**Application for Permission under Section 16 of the Town Planning Ordinance (Cap.131)
Proposed Temporary Open Storage of Vehicles and Construction Materials with Ancillary Office and
Associated Filling of Land for a Period of 3 Years at
Lots 1512, 1513 S.A, 1513 S.B, 1513 RP, 1514 S.A, 1514 S.B, 1514 RP, 1515, 1516 and 1632 in D.D. 107 and
Adjoining Government Land, Fung Kat Heung,
Yuen Long, New Territories
(Planning Application No. A/YL-KTN/1159)**

Submission of Further Information 2

**Drainage Impact Assessment
(Section 16 Planning Application No. A/YL-KTN/1159)**

Revised Filling of Land Plan

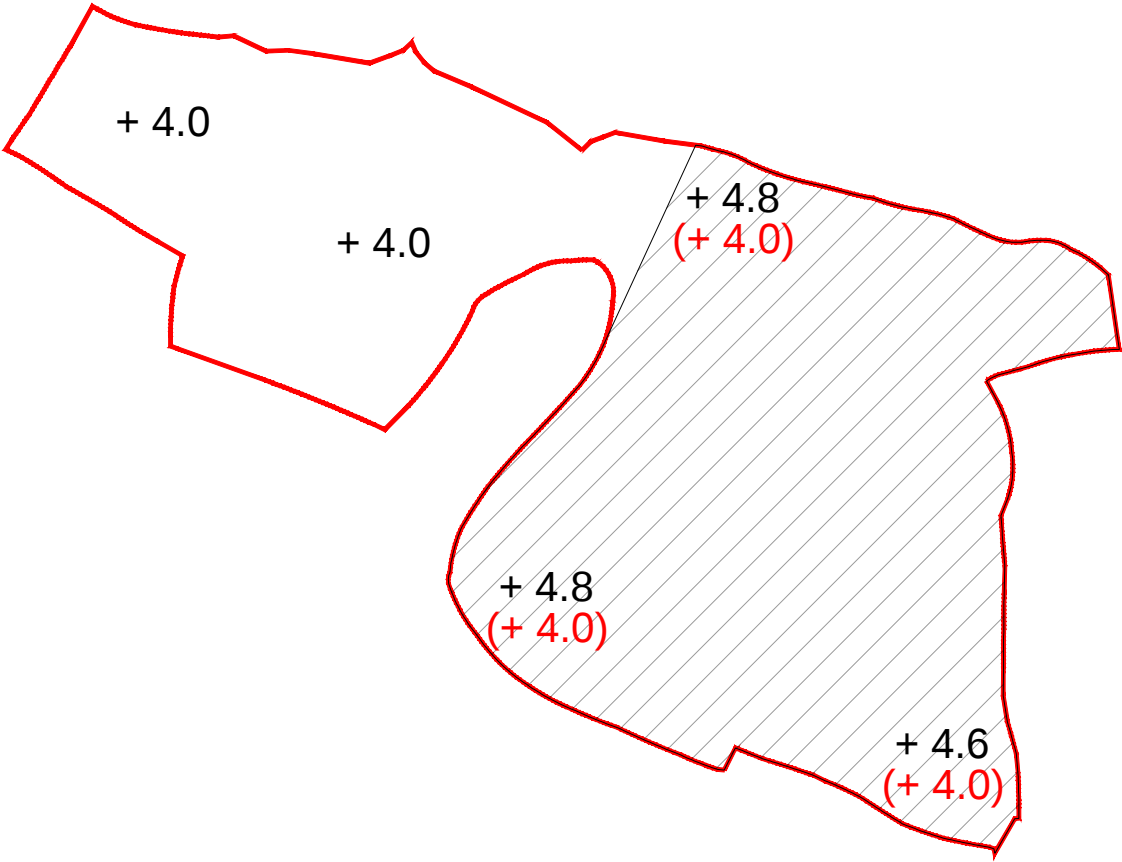
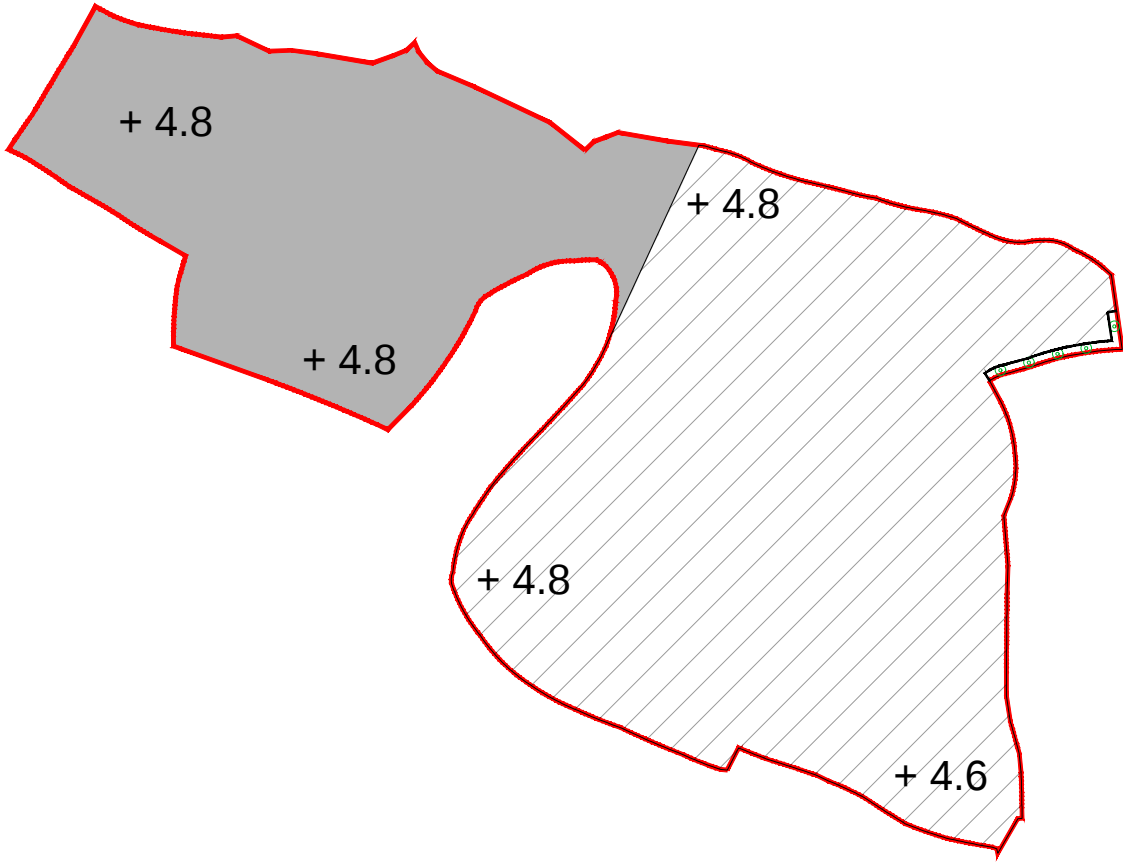
Due to the proposed landscape treatment measures, the total land filling area is reduced from 7,627m² to 7,600m² (-27m²) to make room for the proposed planter area for new trees. Please refer to **Attachments 5 and 6** for the subject change.

APPLICATION SITE AREA : 7,627 m² (ABOUT)
PROPOSED PLANTER AREA : 27 m² (ABOUT)
TOTAL HARD-PAVED AREA : 7,600 m² (ABOUT)
EXISTING HARD-PAVED SURFACE AREA : 4,913 m² (ABOUT)
PROPOSED FILLING OF LAND AREA : 2,687 m² (ABOUT)
PROPOSED LAND FILLING DEPTH : NOT MORE THAN 0.8 m
PROPOSED SITE LEVELS : +4.0 mPD TO +4.8 mPD
MATERIAL OF FILLING FOR SITE FORMATION : SOIL WITH CONCRETE AND ASPHALT
